**CITY OF BALCH SPRINGS, TEXAS
ORDINANCE NO. 3255-22**

AN ORDINANCE OF THE CITY OF BALCH SPRINGS, TEXAS, AMENDING CHAPTER 14, BUILDINGS AND BUILDING REGULATIONS, ARTICLE II, BUILDING CODE, DIVISION 2, STANDARDS, BY AMENDING SECTIONS 14-52 AND 14-53 OF THE CODE OF ORDINANCES OF THE CITY OF BALCH SPRINGS, TEXAS, TO PROVIDE FOR UPDATING THE VERSION OF THE INTERNATIONAL BUILDING CODE (2021), INTERNATIONAL EXISTING BUILDING CODE (2021), INTERNATIONAL RESIDENTIAL CODE (2021), INTERNATIONAL SWIMMING POOL AND SPA CODE (2021), INTERNATIONAL FUEL AND GAS CODE (2021), INTERNATIONAL ENERGY CONSERVATION CODE (2021); AMENDING CHAPTER 14, BUILDINGS AND BUILDING REGULATIONS, ARTICLE III, ELECTRICAL CODE, DIVISION 3, STANDARDS, BY AMENDING SECTIONS 14-171 AND 14-172 OF THE CODE OF ORDINANCES OF THE CITY OF BALCH SPRINGS, TEXAS, TO PROVIDE FOR UPDATING THE NATIONAL ELECTRIC CODE (2020); AMENDING CHAPTER 14, BUILDINGS AND BUILDING REGULATIONS, ARTICLE IV, PLUMBING CODE, BY AMENDING SECTIONS 14-201 AND 14-202 OF THE CODE OF ORDINANCES OF THE CITY OF BALCH SPRINGS, TEXAS, TO PROVIDE FOR UPDATING THE VERSION OF THE INTERNATIONAL PLUMBING CODE (2021); AMENDING CHAPTER 14, BUILDINGS AND BUILDING REGULATI

FIGURE D103.6
FIRE LANE SIGNS

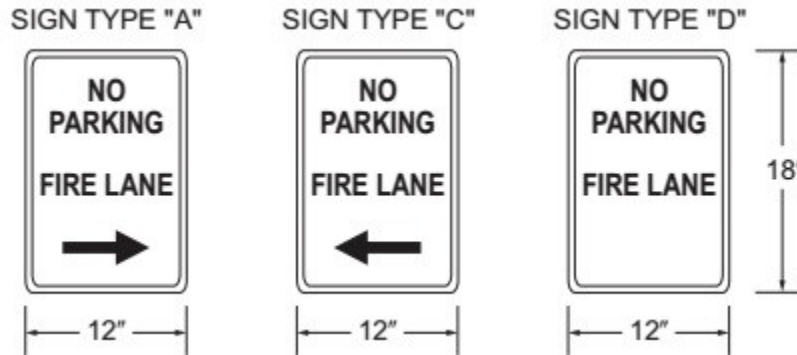
*****Section D103.6; change to read as follows:**

(2) Signs – Signs shall read “NO PARKING FIRE LANE” or “FIRE LANE NO PARKING” and shall be 12” wide and 18” high (See Figure D103.6). Signs shall have red letters on a white reflective background, using not less than 2” lettering. Signs shall be permanently affixed to a stationary post and the bottom of the sign shall be six feet, six inches (6’6”) above finished grade. Signs shall be spaced not more than fifty feet (50’) apart along both sides of the fire lane. Signs may be installed on permanent buildings or walls or as approved by the Fire Chief.

D103.6 Signs–Marking. Striping, signs, or other markings, when approved by the *fire code official*, shall be provided for fire apparatus access roads to identify such roads or prohibit the obstruction thereof. Striping, signs and other markings shall be maintained in a clean and legible condition at all times and be replaced or repaired when necessary to provide adequate visibility.

(1) Striping – Fire apparatus access roads shall be continuously marked by painted lines of red traffic paint six inches (6”) in width to show the boundaries of the lane. The words “NO PARKING FIRE LANE” or “FIRE LANE NO PARKING” shall appear in four inch (4”) white letters at 25 feet intervals on the red border markings along both sides of the fire lanes. Where a curb is available, the striping shall be on the vertical face of the curb.

Figure 307.4

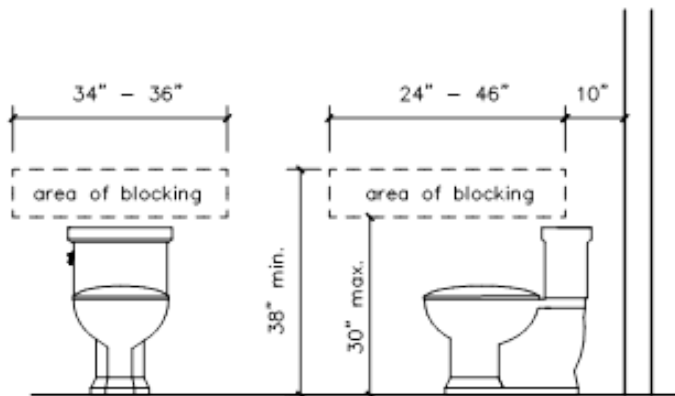
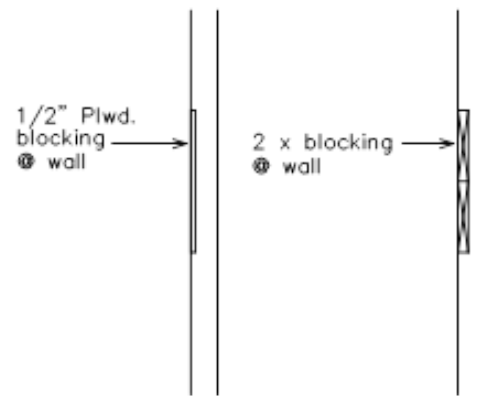
*****R307.3 Blocking.** Required at one toilet at grade level. Blocking per Sec. R307.4 and Figure 307.4, shall be installed at rear wall and one wall adjacent to toilet at the lowest living level where a toilet is provided.

*****R307.4 Blocking.** Blocking may be 1/2" plywood or equivalent or 2 x solid wood blocking flush with wall.

(Reason: Blocking at initial construction allows for ease of use for future grab bar installation if desired for homeowners. Ties into Dallas Builders Association of Universal Design Elements concepts for CAPS (Certified Aging in Place Specialists) professionals.)

****Figure R602.6.1; delete the figure and insert the following figure:**

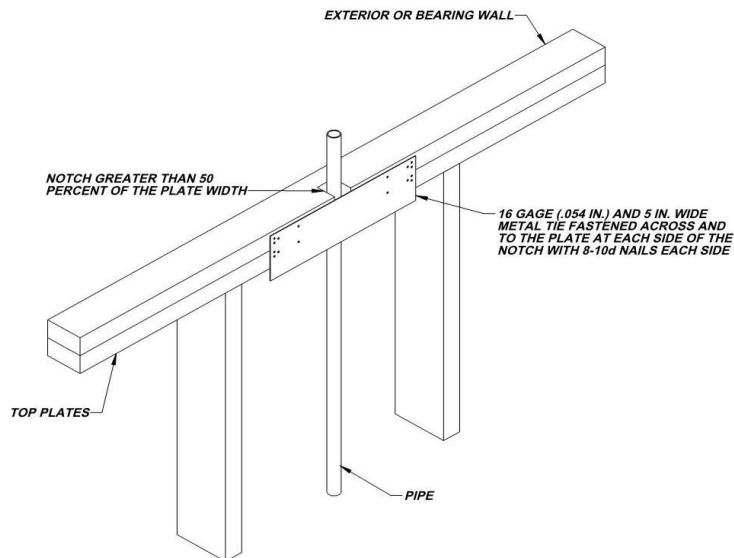
R602.6.1 Drilling and notching of top plate. When piping or ductwork is placed in or partly in an exterior wall or interior load-bearing wall, necessitating cutting, drilling or notching of the top plate by more than 50 percent of its width, a galvanized metal tie not less than 0.054 inch thick (1.37 mm) (16 Ga) and ~~4 1/2 inches (38 mm)~~ 5 inches (127 mm) wide shall be fastened across and to the plate at each side of the opening with not less than eight 10d (0.148 inch diameter) having a minimum length of 1 1/2 inches (38 mm) at each side or equivalent. Fasteners will be offset to prevent splitting of the top plate material. The metal tie must extend a minimum of 6 inches past the opening. See figure R602.6.1. *{remainder unchanged}*

(Amendment forward to 2015 IRC carried forward to 2018 IRC also provides additional assurance of maintaining the integrity of the framing by spreading the nailing pattern.)

ADD: Figure: 25 TAC §265.186 (e) (6)

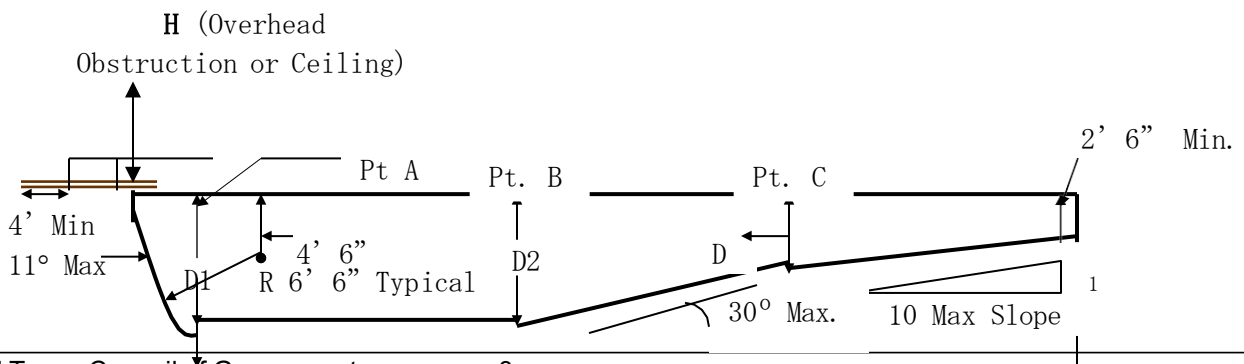
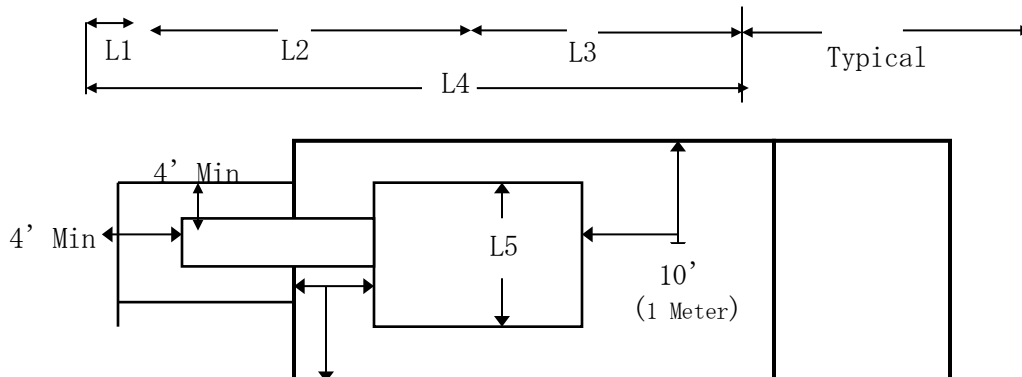
402.12 Water envelopes. The minimum diving water envelopes shall be in accordance with ~~Table 402.12~~ **Texas department of State Health services, Administrative Code Title 25, Chapter 265, Section 186 (e) and Figure: 25 TAC 256.186 (e) (6).** (Delete Table 402.12 and Figure 402.12)

(Reason: To avoid conflict with 25 TAC Chapter 265.)
